Our Case Number: ABP-318446-23
Planning Authority Reference Number:

Re: Proposed construction of Coumnagappul Wind Farm consisting of 10 no. turbines and associated infrastructure.
In the townlands of Coumnagappul, Carrigbrack, Knockavanniamountain, Barricreemountain Upper and Glennaneanemountain, Skeeheans, Lagg, Co. Waterford.
(www.coumnagappulwindfarmSID.ie)

Observation Made by : Jacqueline Walsh

Case : Coomnagappal Windfarm, Ballymacarby, Co. Waterford Case No 318446

Observation Start(orange) and End(Grey) mapped against Daylight hours - 0 = Sunrise. Watches that started before Sunrise were set to 0

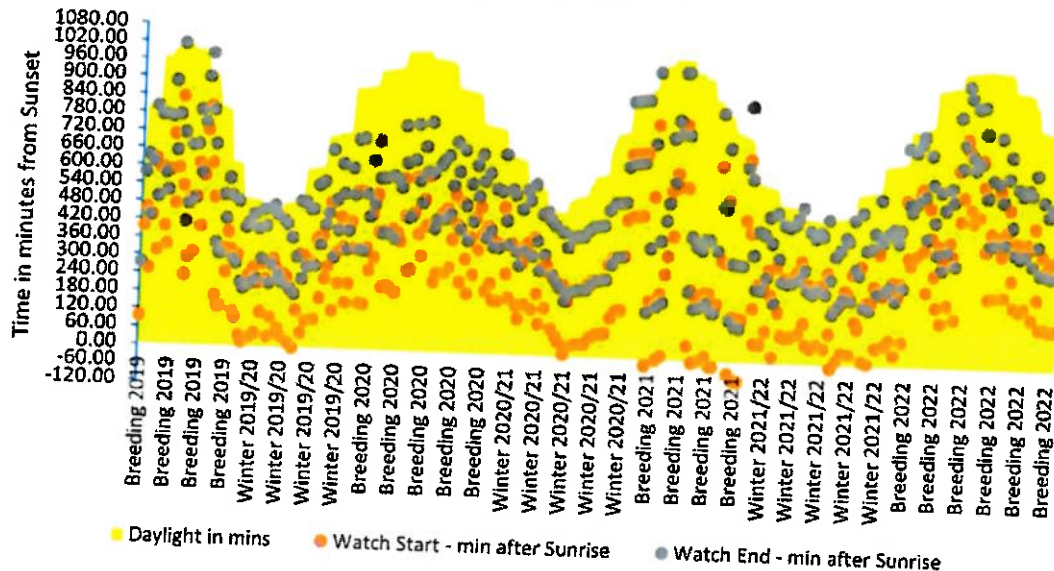
I took data from sunrise.maplogs.com for Ballymacarby Co. Waterford. This provides the time of Sunrise and Sunset for historic periods. I calculated the start and end time of each watch from Sunrise in minutes. I then mapped the data, with Sunrise set to 0, the start of the watch as the time in minutes from sunrise on that particular date, the end time of the watch as the time in minutes from sunrise for that particular date and the sunset time in minutes from sunrise. As can be clearly seen from the graph below – which is based on the watch dates and times provided in Appendix 10.1 – Watches were not spread over the full daylight period. Where watches started before noon, they started on average two and a half hours after sunrise. Only during the winter periods was there observation over full daylight hours.

There were a number of observations which had a start time of before Sunrise or an end time after sunset. As an example, see table below

Figure 6. Vantage Point location and corresponding viewsheds

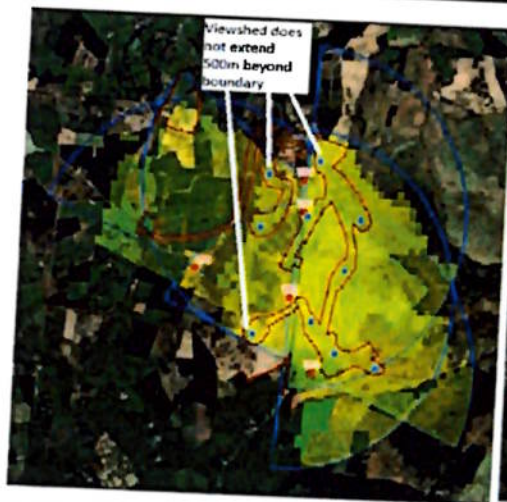
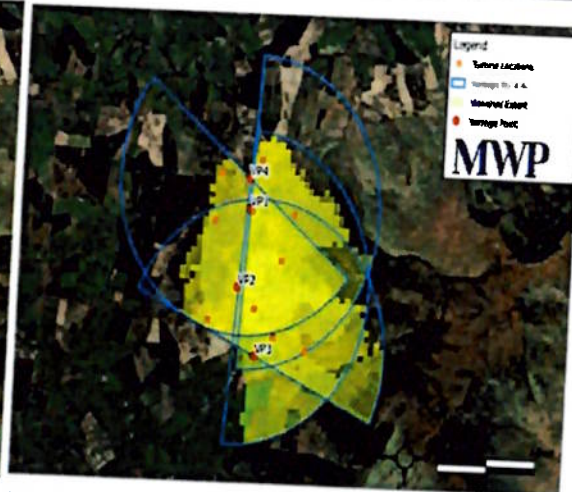
The scale on Figure 6 shows a 500m scale which shows that the viewshed does not extend 500m past the proposed turbine location for Turbines 1, Turbine 2 and Turbine 10. As the flight data from this Vantage Point survey is the key input into the Collision Risk Model, it raises questions as to the integrity of any modelling based on this data which is incomplete.

All observations from VP5 are excluded. In terms of viewshed coverage, the comparison of the two maps in relation to viewshed, amply demonstrates the difference in coverage. The Map on the left is from Appendix 10.1 demonstrating the extent of the area surveyed (not withstanding its failure to cover the 500m buffer zone), the Map on the right is from Appendix 10.2, covering the viewpoints of the observational data that was actually considered for input into the model. There is restricted flight impact data of all the turbines on the Western part of the site. Appendix 10.2 does not indicate in percentage terms – defined by SNH(2017) – how much of the flight survey area was actually covered when the subset of Vantage Points was used. However, its clear that while in Appendix 10.1, there were issues around the viewshed extending to the 500m boundary for proposed Turbine 1, 2, and 10, the Map from the Appendix 10.2 shows that there was not adequate data relating to Turbine 3 either. Therefore, the data associated with 40% of the proposed locations is limited and not adhering to the guidelines, or to what was said in the text.

Figure 7. Transect survey routes

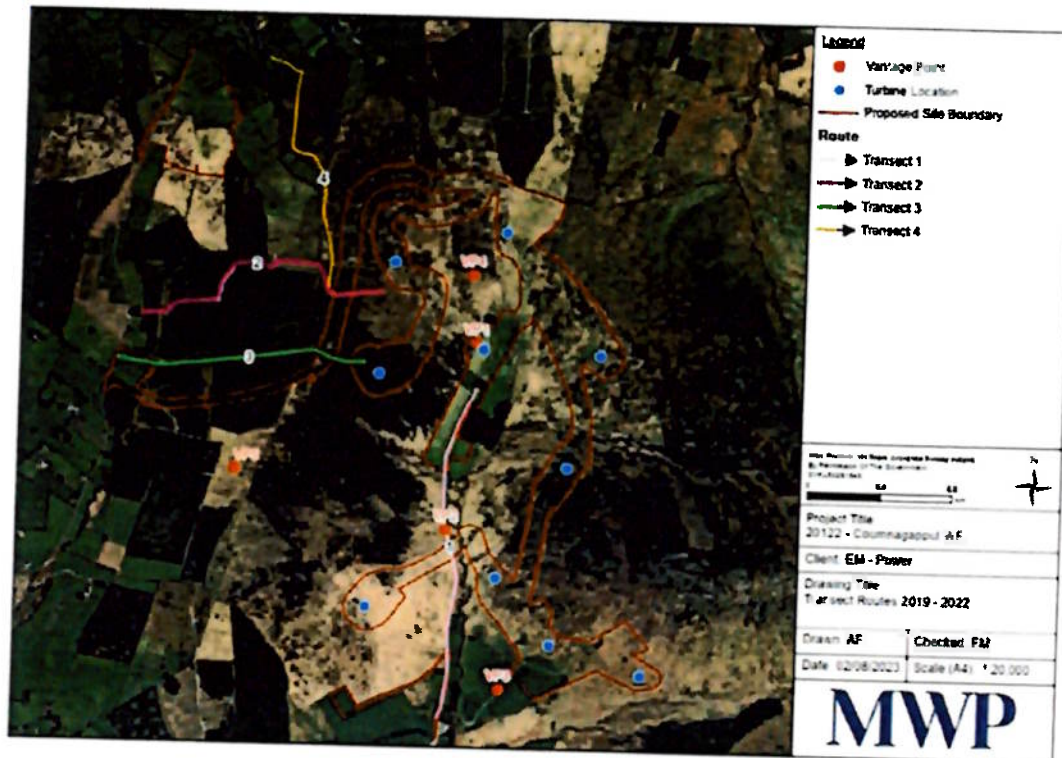
Transect Route 1 is a farm track, in the lowland portion of the proposed development, in the valley. Transect 2,3 and 4 in the western area are in a mixture of conifer and agri grassland. It is difficult to understand how a habitat of conifer and agricultural grassland could be identified as differing only "slightly" from the predominantly occurring habitats of wet heath (57.99ha) and dry heath (51.83) on the site. This paragraph is written in a potentially misleading way and could infer that the site's predominantly occurring habitats was conifer forestry and agricultural grassland not heath.

It seems odd that given 6 of the 10 turbines proposed are on the eastern boundary of the site and yet the transect routes do not engage with this area at all – particularly given the stated aim of assessing general bird distribution throughout the site. Based on the maps, all the turbines are actually located on heath, yet the transect surveys are based in grassland and conifer areas and through agricultural land. Only the early part of Transept No 1 appears to within 100m of heath.

The use of establishing a distribution survey by a 100m overview from the transect route is a significant departure from the SNH (2017) guidance which identifies the survey area for a breeding and distribution survey area of 500m beyond the planning boundary.

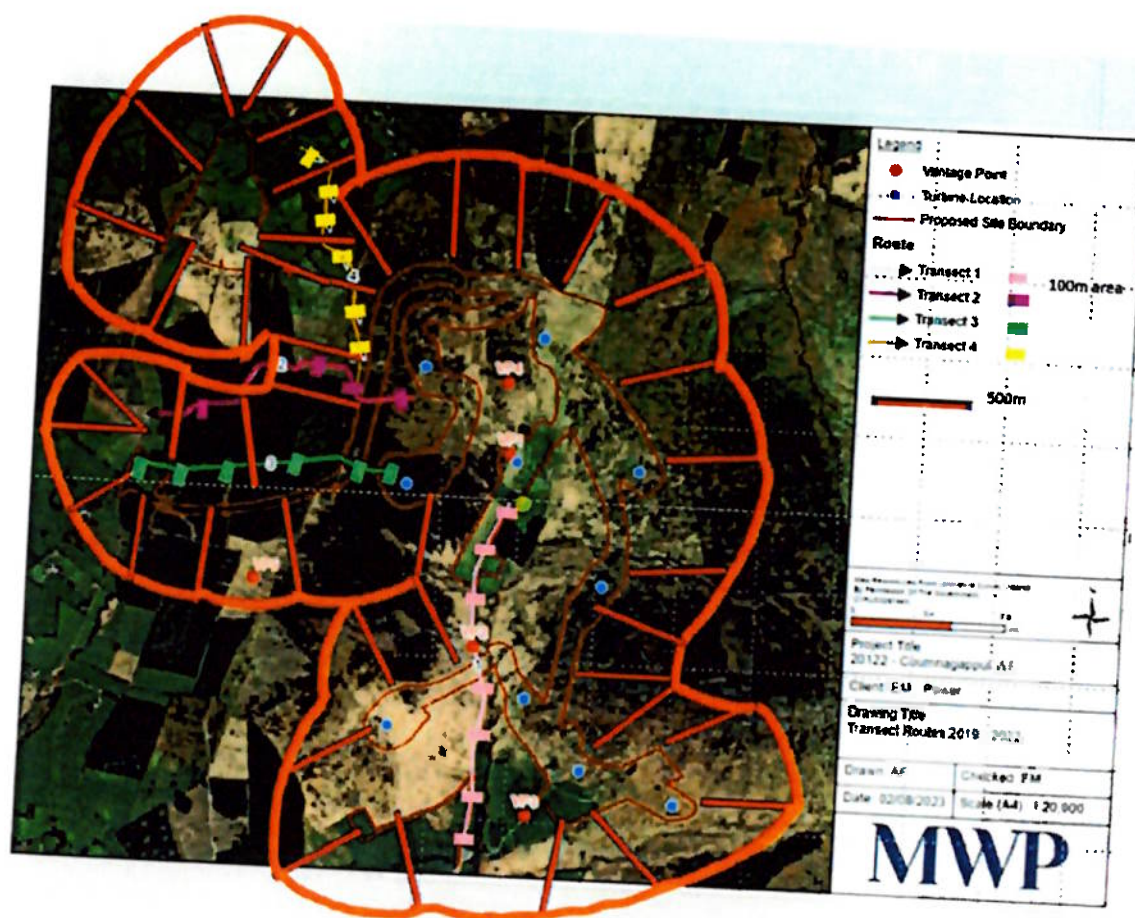
The map below which is crude but reasonably accurate – and I have tried to demonstrate the difference between the approach adopted and the recommended one. Using the scale provided, I have overlain the minimum area recommended for survey, which is 500m from the boundary – red curves and lines measuring 500m. SNH (2017) requires additional distance for some species. I have also shown blocks on the transect route representing 100m which is the area surveyed. I believe this graphically illustrates the shortcoming in the abundance and distribution survey.

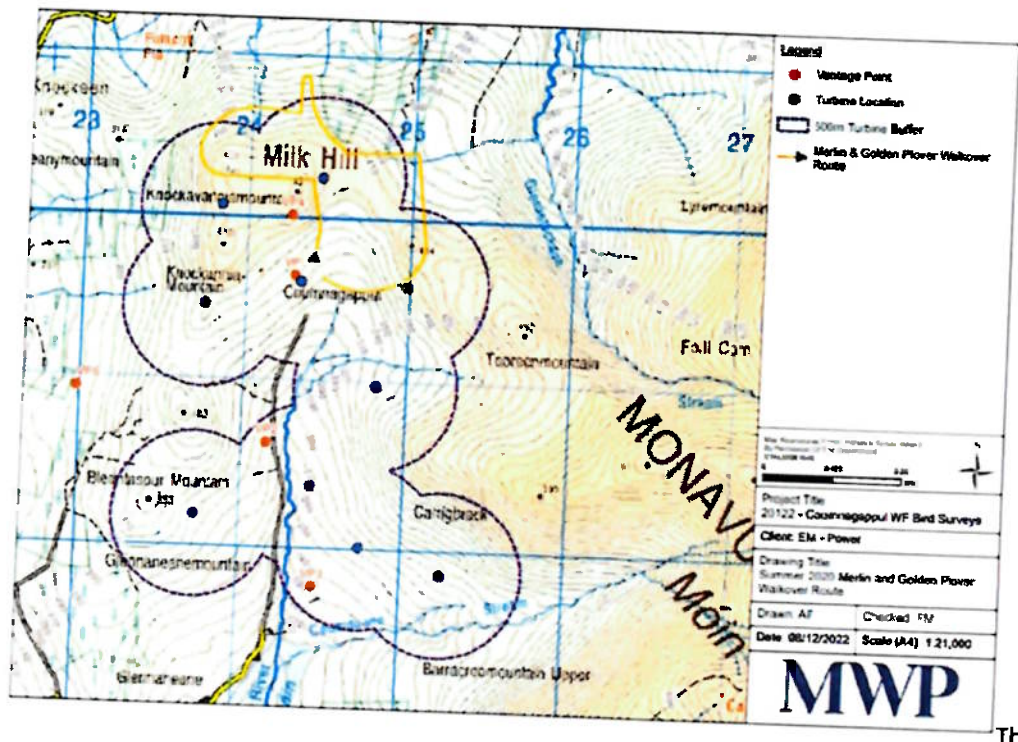
This walkover route show below was identified for Merlin, Golden Plover and Red Grouse. This is primarily within the northern part of the site. The route was followed on the 9th June 2020 and 17th July 2020 to survey for Merlin, Golden Plover and Red Grouse. The route was repeated on 2nd June 2022 and 5th July 2022 to survey for Breeding Red Grouse.

There are a number of issues with this. Red Grouse was heard as a secondary observation during the Flight survey calling on two occasions to the east of VP2 in the early breeding season of April & June 2021. Yet the walkover route was almost as far away as possible from this location. Furthermore, in relation to the timing of these surveys - as was noted in both Chapter 10 and Appendix 10.1
